Access Compliance Report

Public Rights-of-Way

(Curb Ramps)

Intersection ID: 15126	Main Street: DOMINO_CT	Cross Street: MONROE_RD	Location: W
ADA ID: 77BCE1D0B662	Ramp Type: Para	Initial Pass/Fail: Fail	Overall Compliance: No
Severity Score: 13.75			
Codes/Mitigation Info/Possible Solution		Field Measurements/Component Compliance

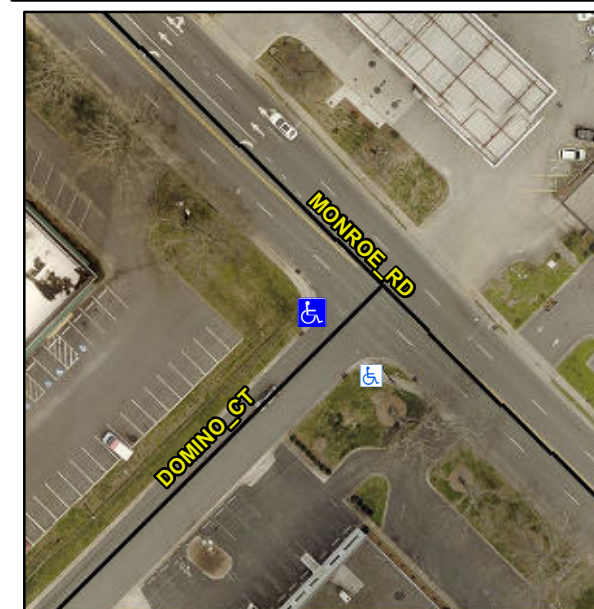
RT RP < 5%, CURB LIP 0.5

R304.3.2, R304.5.3

Compliance	Description	Data	Compliance	Description	Data
N/A	Ramp Length LT (in)	35.0	N/A	Ramp Length RT (in)	51.0
Yes	Ramp Width LT (in)	61.0	Yes	Ramp Width RT (in)	59.5
No	Ramp Slope LT (%)	9.3	Yes	Ramp Slope RT (%)	4.6
Yes	Ramp XSlope LT (%)	1.0	No	Ramp XSlope RT (%)	2.3
N/A	Landing Length (in)	N/A	N/A	DWS Provided?	N/A
N/A	Landing Width (in)	N/A	N/A	DWS Contrast?	N/A
N/A	Landing Slope (%)	N/A	N/A	DWS Length (in)	N/A
N/A	Landing X Slope (%)	N/A	N/A	DWS Full Width?	N/A
N/A	Landing Curb? (Y/N)	N/A	N/A	DWS Offset (in)	N/A
N/A	Shared Landing?	N/A			
N/A	Gutter Ponding?	N/A	N/A	Gutter Slope (%)	N/A
N/A	Gutter Lip Ht (in)	N/A	N/A	Gutter X Slope (%)	N/A
N/A	Painted X Walk1?	No	N/A	Painted X Walk2?	N/A
	X Walk 1 Direction	To SE		X Walk 2 Direction	N/A
N/A	X Walk 1 Width (in)	N/A	N/A	X Walk 2 Width (in)	N/A
	X Walk 1 Slope (%)	4.6		X Walk 2 Slope (%)	N/A
	X Walk 1 X Slope (%)	3.1		X Walk 2 X Slope (%)	N/A
N/A	Ramp inside XWalk1?	N/A	N/A	Ramp inside XWalk2?	N/A

Remove & Replace Entire Ramp.
